Wisconsin Electric POWER COMPANY
231 W. MICHIGAN, P.O. BOX 2046, MILWAUKEE, WI 53201

February 28, 1983

DOCKET NOS. 50-266 AND 50-301
REPLY TO NRC REQUEST FOR ADDITIONAL INFORMATION ON
NUREG-0737, ITEMS II.F.1.4, II.F.1.5, AND II.F.1.5
POINT BEACH NUCLEAR PLANT, UNITS 1 AND 2

REPLY TO REQUEST FOR ADDITIONAL INFORMATION
ON NUREG-0737 ITEMS

CONTAINMENT WIDE RANGE PRESSURE

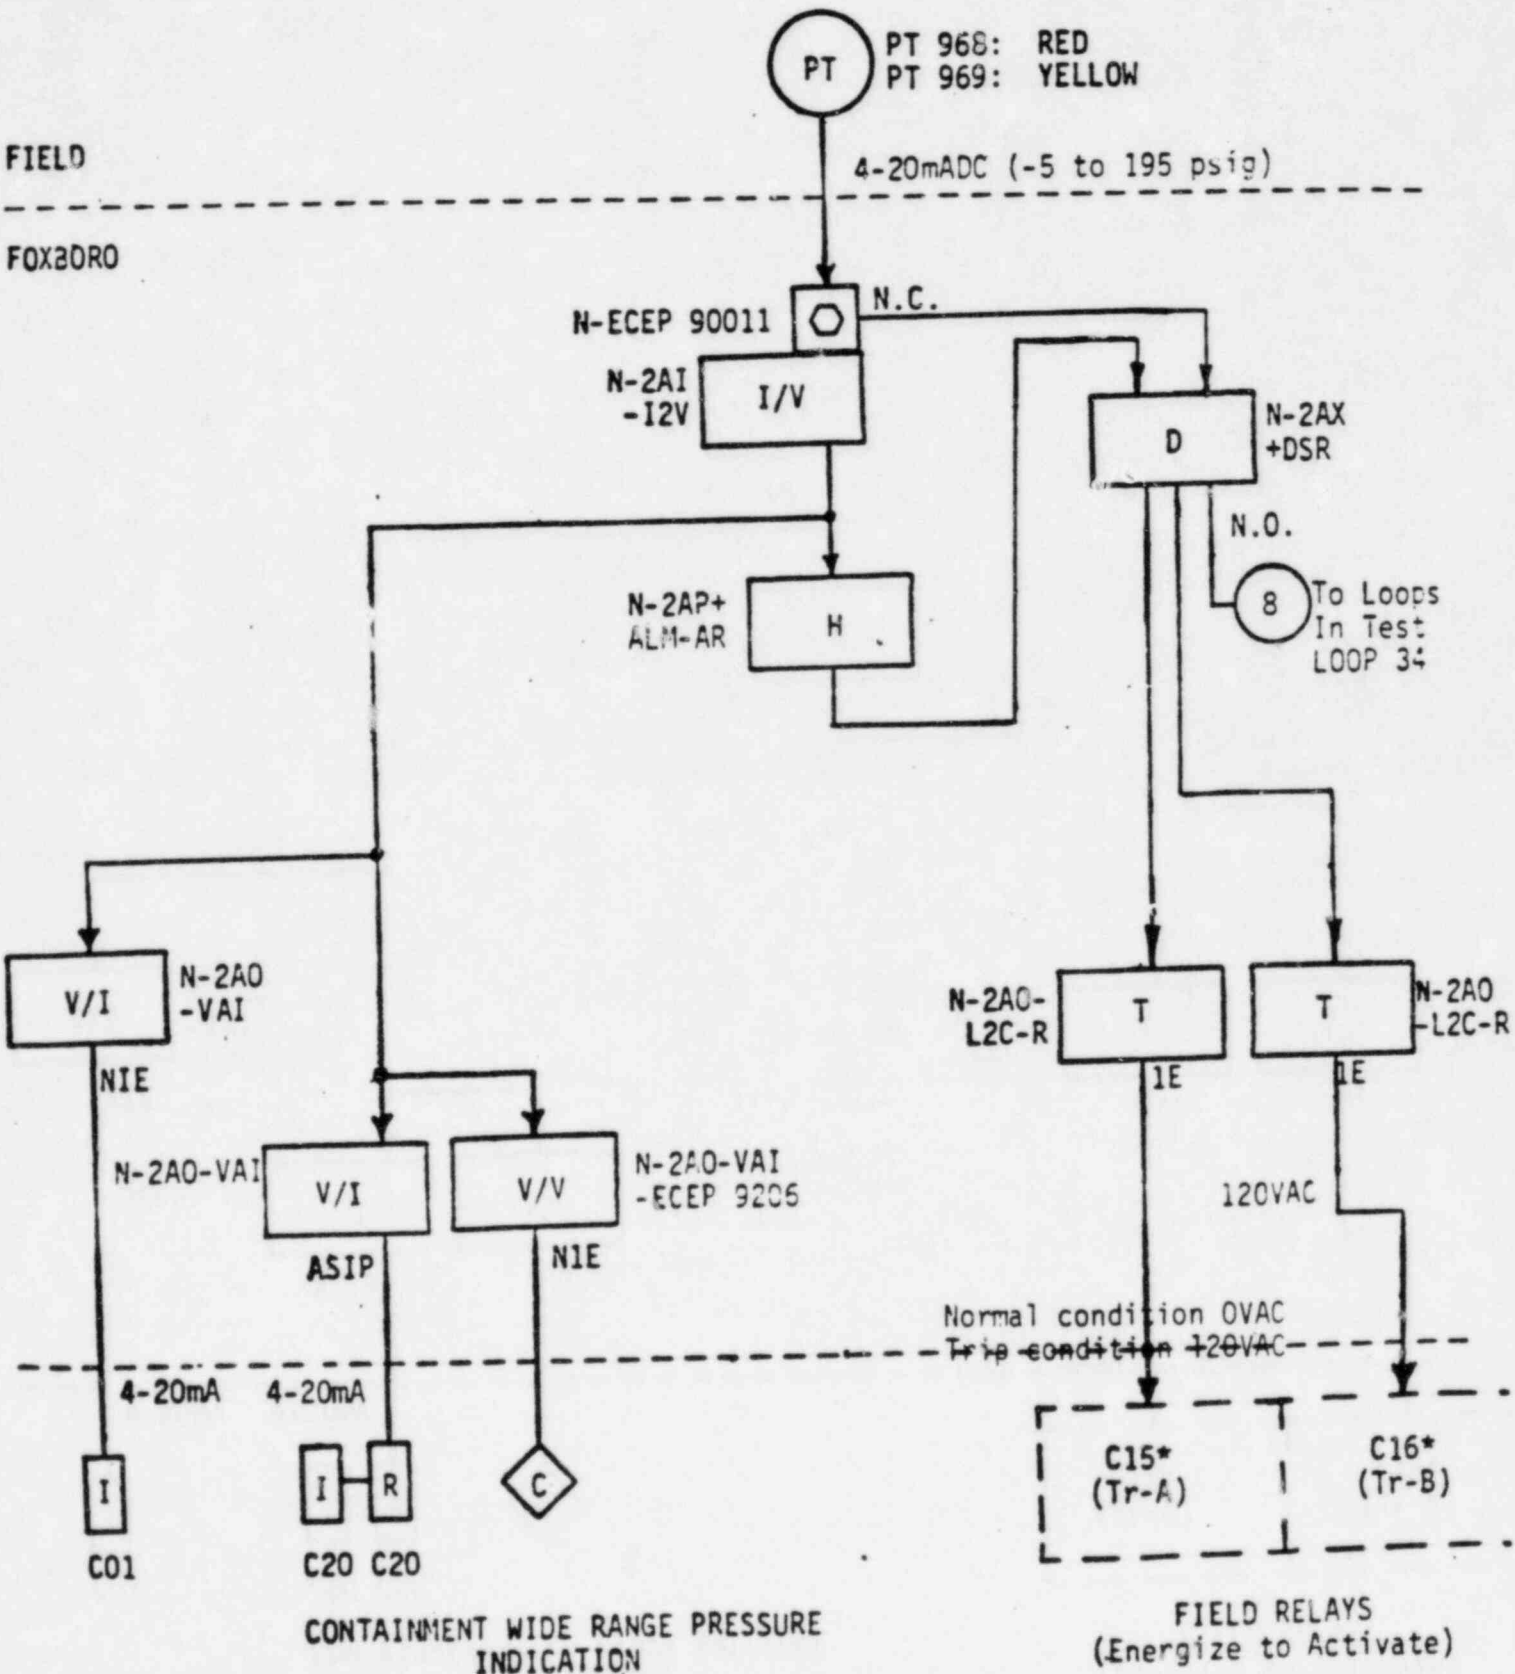
- 2a. Provide a block diagram of the configuration of modules that make up your PMS. Provide an explanation of any details in the block diagram that might be necessary for an understanding of your PMS accuracy and time response.

A block diagram of the Containment Wide Range Pressure channel, Loop 1, is attached.

The time constant of the pressure transmitter is approximately 0.16 seconds. The time constant of the control room indicator is approximately 0.5 seconds. The full scale response time for the control room recorder is approximately 5 seconds. The time constants of other modules are negligible in comparison to the time constants listed.

CONTAINMENT SUMP LEVEL

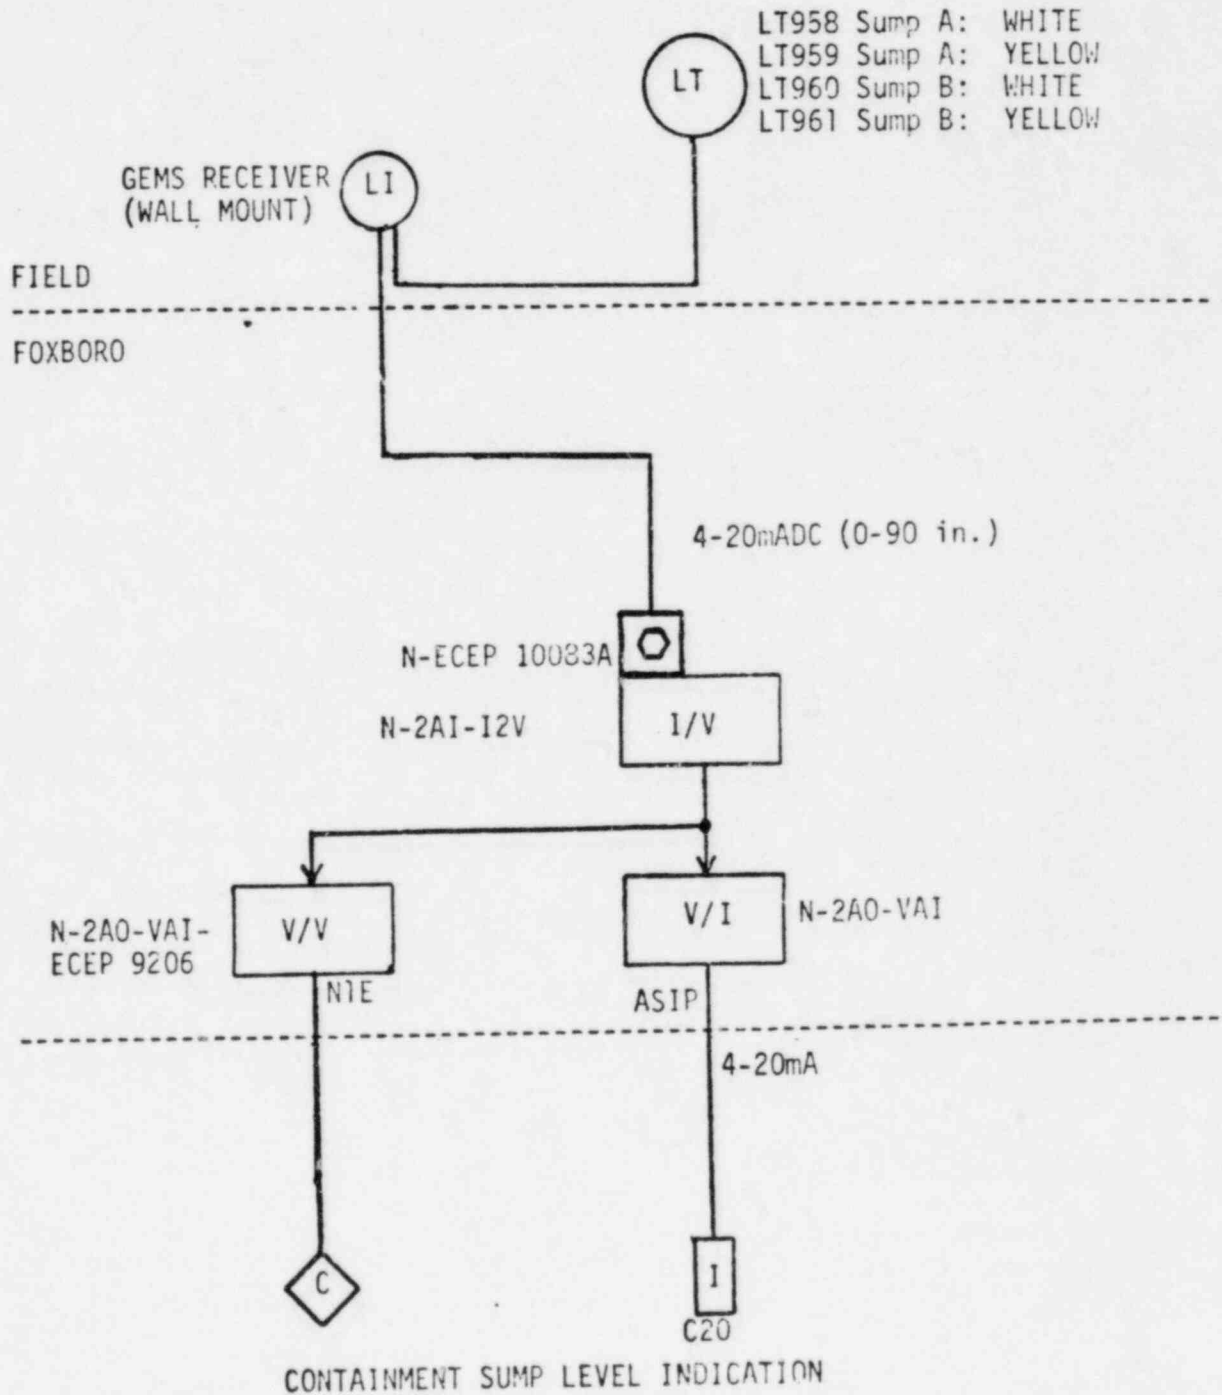
- 3a. Provide a block diagram of the configuration of modules that make up your WLMS. Provide an explanation of any details in the block diagram that might be necessary for an understanding of your WLMS accuracy.

A block diagram of the Containment Sump Water Level channel, Loop 3, is attached.

CONTAINMENT HYDROGEN MONITOR

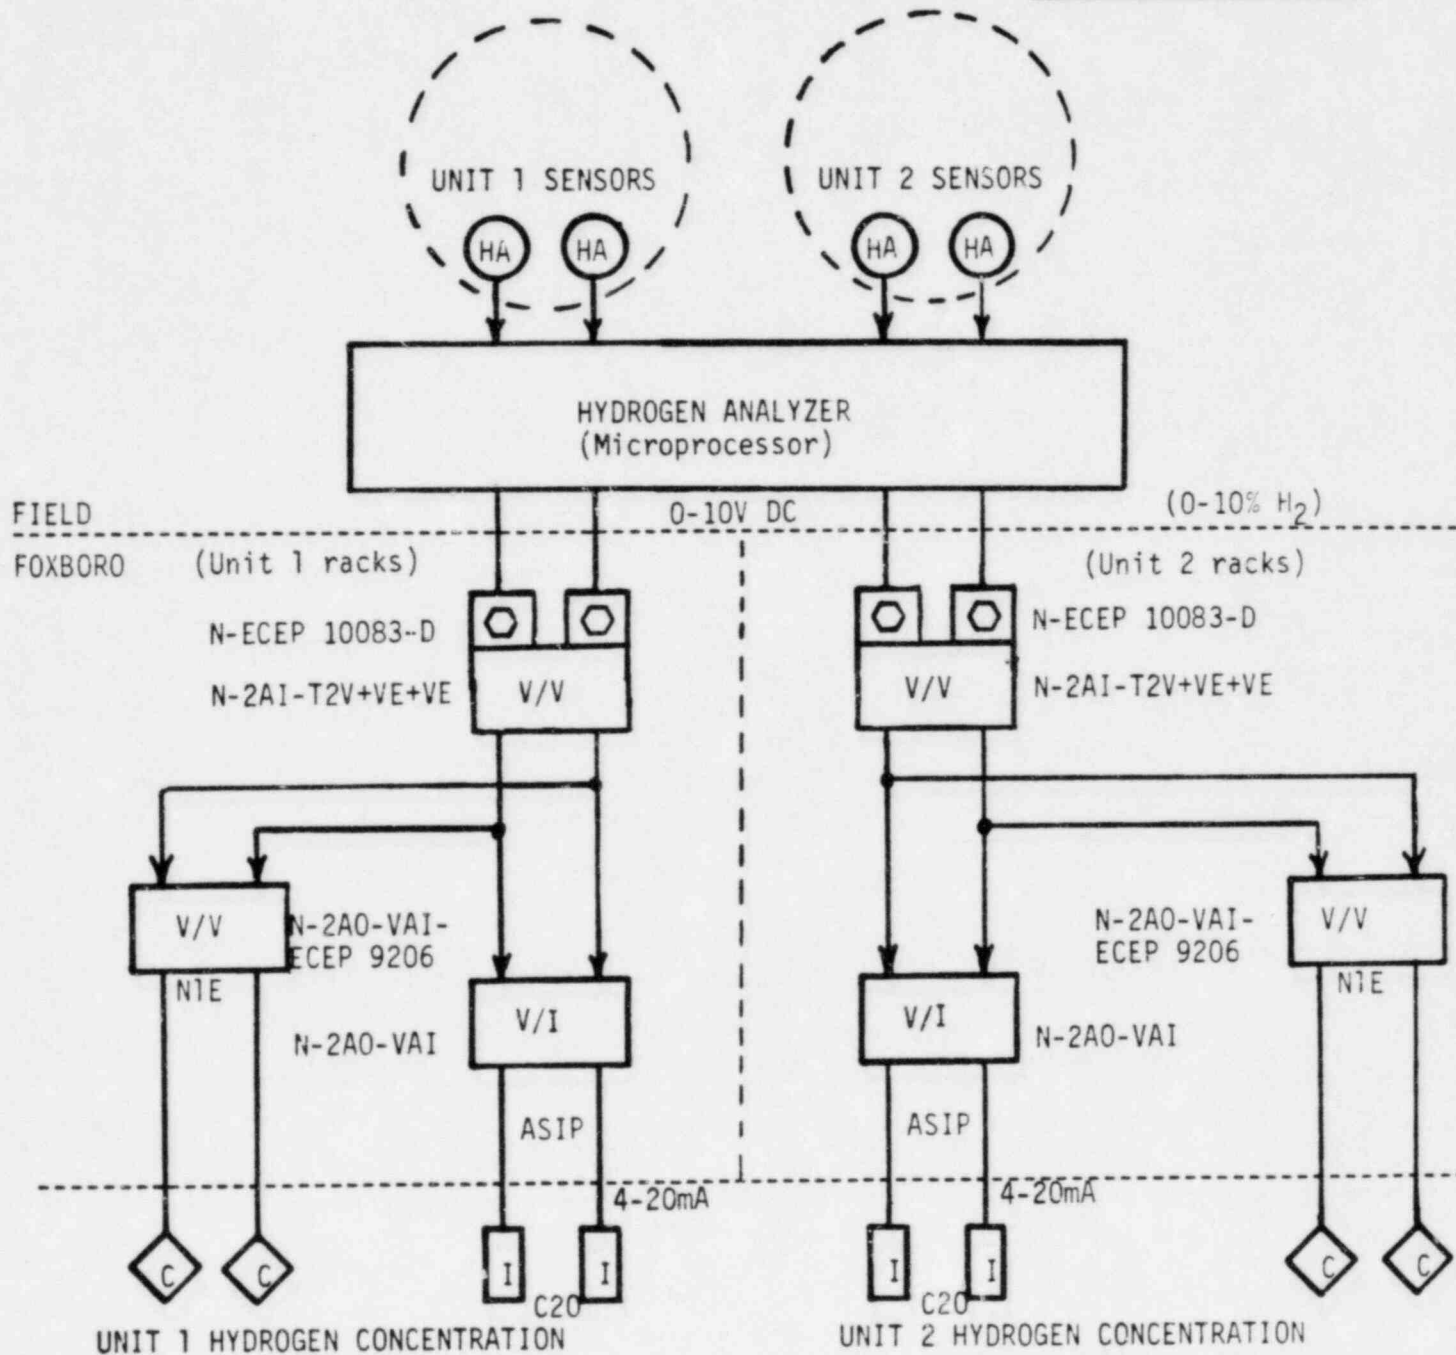
- 4a. Provide a block diagram of the configuration of modules that make up your HMS. Provide an explanation of any details in the block diagram that might be necessary for an understanding of your HMS accuracy. If you have different types of HMSs give this information for each type.

- 4d. Indicate the placement and number of hydrogen monitor intake ports in containment. Indicate any special sampling techniques that are used either to examine one region of containment or to assure that a good cross section of containment is being monitored.

A block diagram of the Containment Hydrogen Monitor channel, Loop 5, is attached.

There are four hydrogen sensors located in each containment. In each containment two of the sensors are located in the containment volume above the operating deck, one sensor is located below the operating deck near the pressurizer relief tank and one is located near the seal table.
